Committee: Cabinet Member Report

Subject: Statutory Consultation - Milner Road - Public Realm Improvements

Appendix 1- Newsletter / Plan

Newsletter / Plan Appendix 1

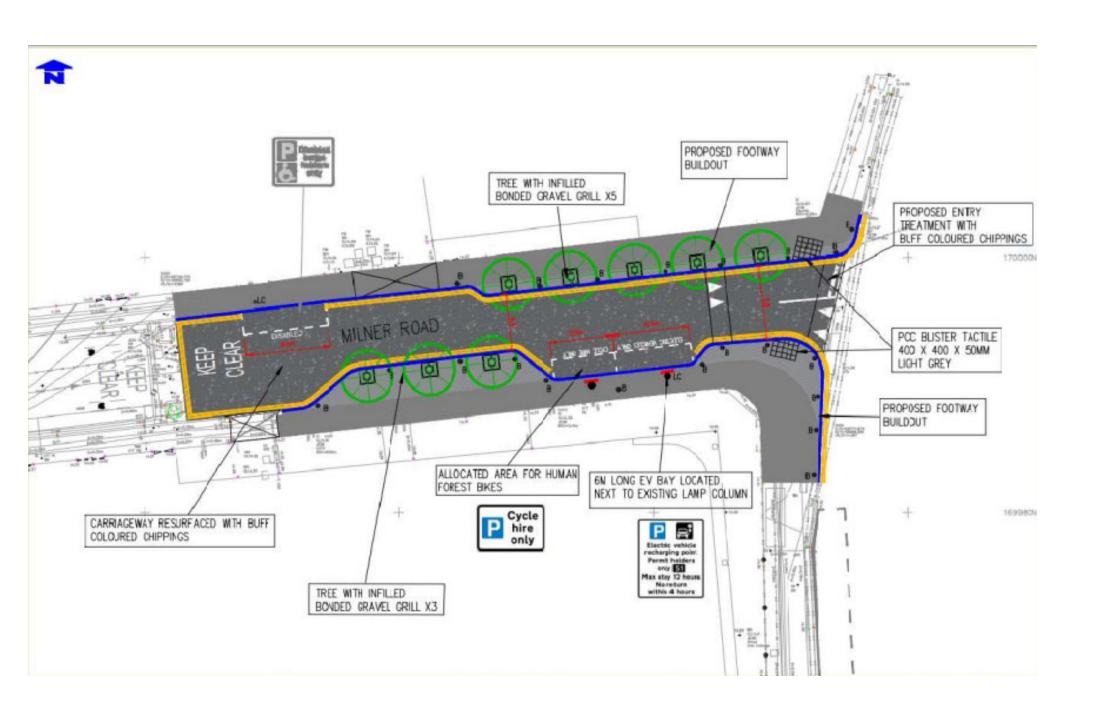
As part of the consultation for the works on Milner Road, I would like to suggest that the proposed EV bay retain the 12-hour limit, but not assigned to S1. As the old Merton Park S1 area already has 15 EV lamp column chargers. I also hope the EV charger will be provided by Char.gy.

The residents are pleased to see your plans for Milner Road, but whilst carrying out this work can you stop the nuisance of motorcycles passing through the posts at the Morden Road end

- 1. There is no allocation for the evening free parking & Sunday free parking we heavily rely on we want to understand why we are not being compensated for taking this away from us as you are devaluing our property?

- 2. My Mother is significantly immobile and for her to visit we need to be able to park a car outside for free so she has short and easy access to my home. Sundays were the only day she would travel from the midlands with my sister so she can visit me and my children. Now we have no parking she will be in too much paint to walk a distance once the car is parked without getting a fine!

- 3. This has a significant impact on our local economy the gym downstairs and yoga house which are open on Sundays will lose Sunday customers due to no parking

- 4. The bin men entering our road will now have to struggle more to get access to our bin rooms which looking at the plans you will block with trees & bike bays.

- 5. Most importantly there is no easy access considered for emergency services do you know our building is currently at tribunal as we are not fire safe. Our solicitor can give you more detail about our case currently at Tribunal. Happy to provide evidence and proof should it be requested. We need to make sure there is easy access for the FIRE services to get through without any obstacles. Please pause the works until this is sorted.

We will lose our ability to park on the street outside the building after 6.30pm in the evenings and all day on Sunday. For many of the residents of Spur house taking this away will greatly damage quality of life. Many of us including myself have elderly relatives & friends visit, and they will lose the ability to park nearby. It will also affect our ability to get crucial utilities individuals into serve us, Plumbers electricians etc....where will they park.

It will also affect our ability to get deliveries, be that from takeaways, or amazon etc as they will no longer be able to park outside the building on the double yellow lines proposed.

Also has the council considered the affect on the local economy? The Yoga Studio and the F45 Gym will lose business in the evenings and on Sundays as their customers will no longer be able to park on Milner Road.

Has the council considered how it will affect the ability of the bin men to get access to remove our bins now the

road will be narrower?

The installation of EV Charge point & bay for electric hire bikes will benefit the community as a whole, but why not place those on a part of Milner Road that already has parking. Residents of Spur House have no ability to get parking permits, and now our ability to park for free is being taken away at certain times is being taken away because of these installations. Seems incredibly unfair.

The narrowing of the road raises the following concerns:

Restriction of access by emergency services if the electric bays are taken up with charging cars/ebikes

Restriction of access for loading/unloading for residents moving or unloading heavy goods.

Restriction of access to delivery vehicles.

Restriction of access to tradesmen who may need to unload machinery to carry out their work for residents.

Restriction of access for refuse collectors to the bin store at Spur House

Loss of free parking for residents of Spur House on a Sunday or after peak hours

Loss of parking for the Yoga studio and gym which will greatly affect their customers.

Would it be possible for Merton Council to provide limited permits to owners of EVs, particularly given they do not contribute to the carbon footprint in the area? This would be a tangible way of demonstrating a commitment to EVs, rather than implementing a policy which puts EVs in the same category as high emissions vehicles.

Even the EV charger outside the building will not be accessible to us as this is also permitted. Are you able to confirm why this is the case given there are EV chargers in the current S1 permit zone?

We would like to voice our objection to the double yellow lines as we need to leave early in the morning to attend meetings of a daily basis and this will prevent us from ever parking outside our own property. This will in turn add an additional 20 minutes every day to reach our car which is incredibly inconvenient and once again seems unfair given we own an EV. This will also impact on local businesses - including the F45 gym - as their members will not be able to park outside for the early morning or evening classes.

If you are familiar with the street, you will be aware that there is clearly space available for a limited number of cars.

The property is car free and therefore legally residents / owners of Spur House are not entitled to permits. To do otherwise would be against the legal agreement; against policy and it would set a precedent.

To ensure that the EV bay is not subject to misuse and since it is within a CPZ, it is necessary for the bay to be subject to the CPZ operational periods. This means that permit holders will be able to use the bay during the operational periods and non-permit holders can use the bay outside the CPZ operational periods.

The existing signs are the appropriate legal signs. Such behaviour is an issue across the borough and even with ANPR camera enforcement, it has been observed that riders simply push their bikes through the restrictions and then continue their journey. Notwithstanding, a request has been made to Parking Services to undertake some enforcement at this location.

Spur House is permit free and all residents would have been informed prior to purchase of the property. The residents of Spur House are not eligible for a permit. This agreement is in place to ensure that the impact of any development on the local community is minimised.

The public highway is not a free car park and no one motorists should rely on free parking provisions. Traffic and parking restrictions on the highway can change at any time and no one resident or road user should consider on street parking as a permanent facility.

The proposed double yellow lines will ensure access for service vehicles and emergency vehicles are maintained at all times. With unregulated evening and weekend parking, service vehicles have no opportunity to stop to load and unload.

With the kerbside space being utilised by some of the Spur House residents, it is debatable that there would be sufficient road space remaining to accommodate deliveries and those visiting The Yoga Studio and the F45 Gym. This area is served extremely well by public transport and in line with the Council's various policies, visitors are discouraged from using private motorised vehicles.

The proposed double yellow lines will ensure access for service vehicles and emergency vehicles are maintained at all times. With unregulated evening and weekend parking, service vehicles have no opportunity to stop to load and unload.

Although it is appreciated that some residents may consider parking a priority, the scheme is not designed to facilitate additional parking and parking provisions would compromise the objective of the improvements and it would be against Council's various policies in discouraging the use of private motorised vehicle; will do nothing to encourage a change in behaviour and attitude toward active travel and use of sustainable transport particularly in an area where it is well served by public transport. The proposed cycle hire bay will provide provisions for active travel and the car club will provide a good alternative for those who may need to drive.

The proposed parking spaces are within a layby and therefore will not impede vehicular access.

Delivery vehicles are permitted to load and unload on double yellow lines. With all available space being used by

visitors and Spur House residents, it is extremely unlikely hat there would be any space available for service vehicles to stop safely to load and unload.

Tradesmen will be able to load and unload on the yellow lines but they will not be able to park. This is no different to the current situation as currently parking is not permitted between 8.30 and 6.30 Mon-Sat.

Refuse collectors will still be able to have access to the bin store and the crossover.

With the kerbside space being utilised by some of the Spur House residents, it is debatable that there would be sufficient road space remaining to accommodate deliveries and those visiting The Yoga Studio and the F45 Gym. This area is served extremely well by public transport and in line with the Council's various policies, visitors are discouraged from using private motorised vehicles.

The proposed double yellow lines will ensure access for service vehicles and emergency vehicles are maintained at all times. With unregulated evening and weekend parking, service vehicles have no opportunity to stop to load and unload.

Spur House is permit free and all residents would have been informed prior to purchase of the property. This is a legal agreement designed to reduce car ownership (regardless of type of vehicle) and to protect existing residents from the impact of the development. The residents of Spur House are not eligible for a permit.

With regards to the EV bay, as per all other EVs in a CPZ, only permit holders will be able to use it during the CPZ operational periods and outside the CPZ hours, non-permit holders will be able to use it. To do otherwise would mean that the bay will be subject to misuse throughout the day and all day as it would encourage non-permit holders and commuters to use this bay as a daily parking facility.
